SUBJECT: Potential Manufacturing Problem With Certain Limit Switch Assemblies Used in ASCO General Controls Hydramotor[®] Actuators.

**POTENTIAL MANUFACTURING PROBLEMS WITH
LIMIT SWITCH ASSEMBLIES USED IN ASCO GENERAL CONTROLS
HYDRAMOTOR® ACTUATORS**

TYPICAL INSTALLATION
NH95 LIMIT SWITCH ASSEMBLY

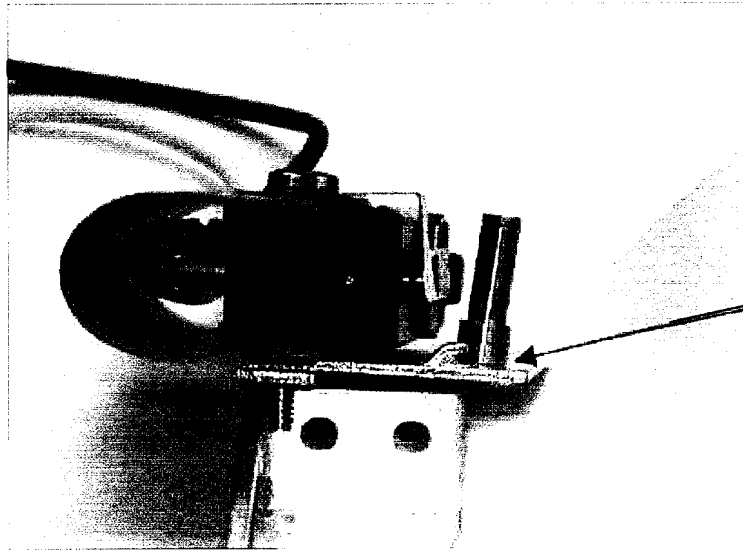
Analysis of the returned Limit Switch Assembly (see attachment 1) revealed that the shaft on which the position sensing lever operates was not secured tightly to the plate, causing wobble of the shaft. This wobble may result in the rotation of the lever past its actuation point, which would leave the switch contacts in the normally open (N.O.) position. This condition will result in the failure of the actuator piston to retract when the Hydramotor® is powered. The shaft is staked to the plate assembly. Manufacturing instructions for this assembly defines the maximum pressure to be applied for the staking press, but no minimum value. This led to variation of the staking process, which resulted in inconsistent and incomplete attachment of the shaft to the plate. (See attachment 2). In addition to the field return, Asco has found several limit switch assemblies in our inventory with this condition.

ASCO will notify all purchasers of affected product of the potential problem. If the affected product is not in service, ASCO will offer to rework it at our factory at no charge. If the product is in service, ASCO will offer retrofit kits at no charge with complete instructions for installation of new limit switch assemblies. The method of forming this staked joint is being revised to ensure complete and consistent assembly of the shaft to the plate. In addition, the manufacturing instructions are being revised to fully define the parameters of this process as well as the testing necessary to confirm the reliability of the shaft-to-plate joining process.
